## AIRWORTHINESS DIRECTIVE

Mini-Nimbus B  
Mini-Nimbus C (up to Serial No. 110)  
Nimbus 2B  
Janus B

Elevator drive bracket - earlier type (Sketch 1 or 3)  
Later type (Sketch 2) is not affected.

GFA AD 323	Issue 2
15.11.1988	Sheet 2 of 5

# SKETCH 1

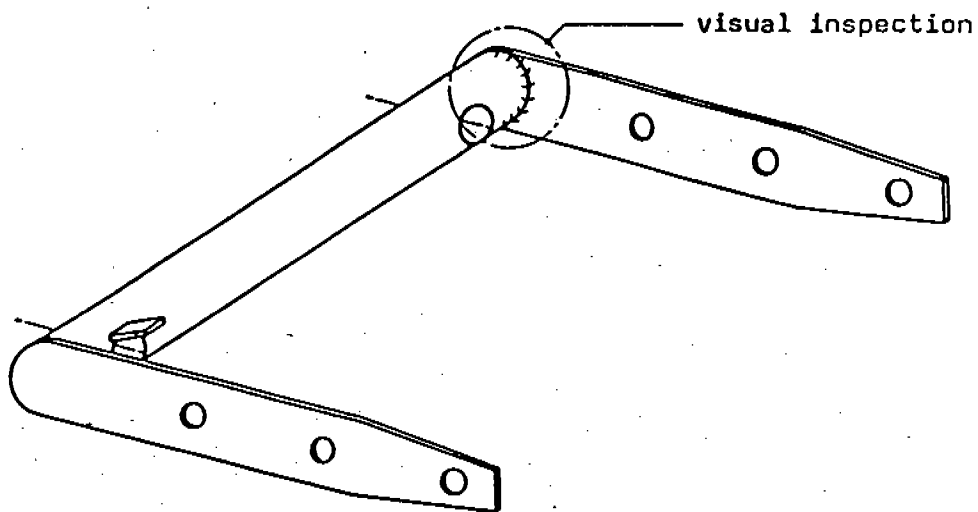
On sailplanes having the earlier type elevator drive bracket according to sketch 1 or sketch 3, a visual inspection for possible cracks must be carried out while twisting the two elevator halves against each other.

The earlier type elevator drive bracket according to sketch 1 must either be replaced by a reinforced bracket (as shown in sketch 2) or be reinforced by means of welding metal strips according to sketch 4.

### SKETCH 3

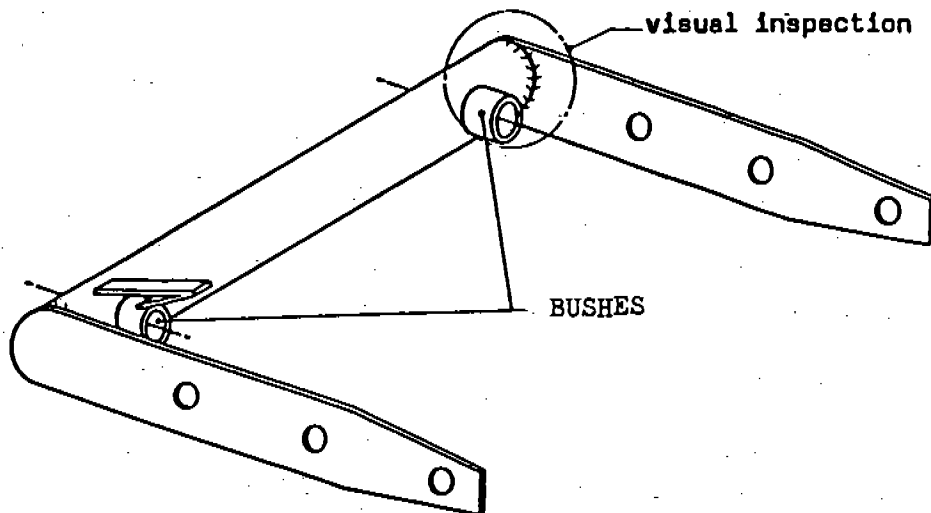
On sailplanes having an earlier type elevator drive bracket according to sketch 3 (bracket with bushings), a reinforcement by means of welding on metal strips according to sketch 4 is required.

### SKETCH 4

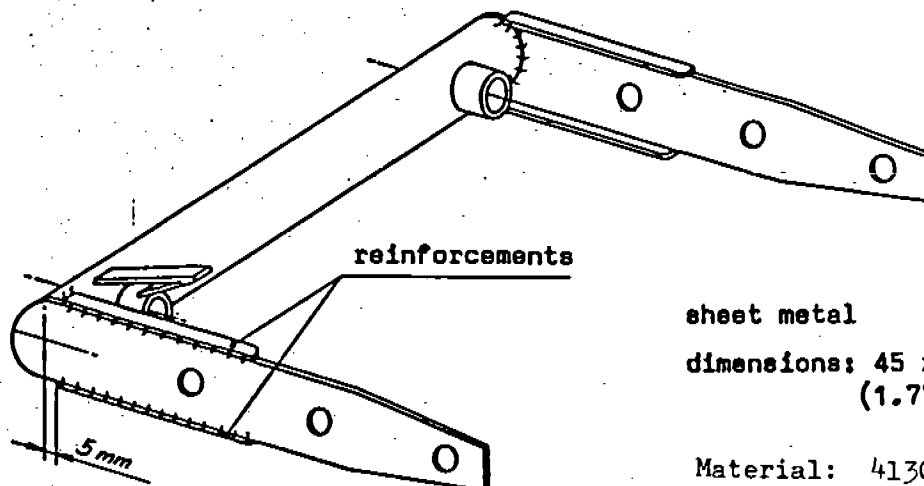
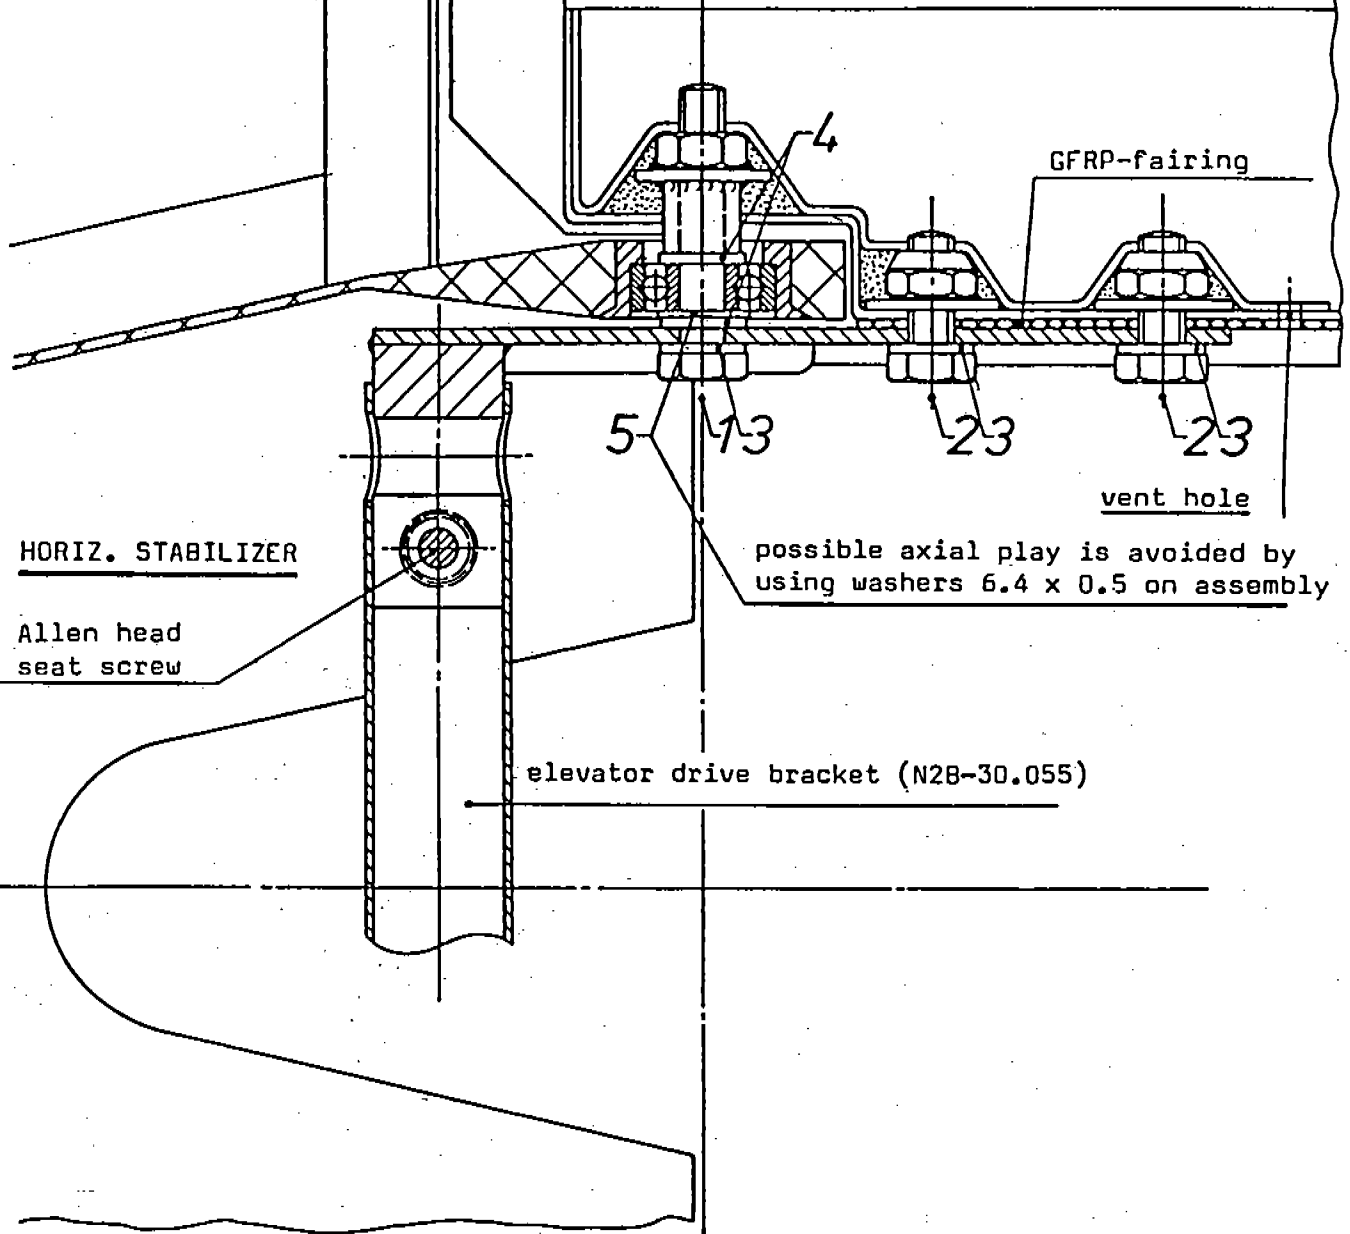
sheet metal

dimensions: 45 x 5 x 1.5 mm  
(1.77 x 0.20 x 0.06 in.)

Material: 4130 steel  
Weld with gas or T.I.G.
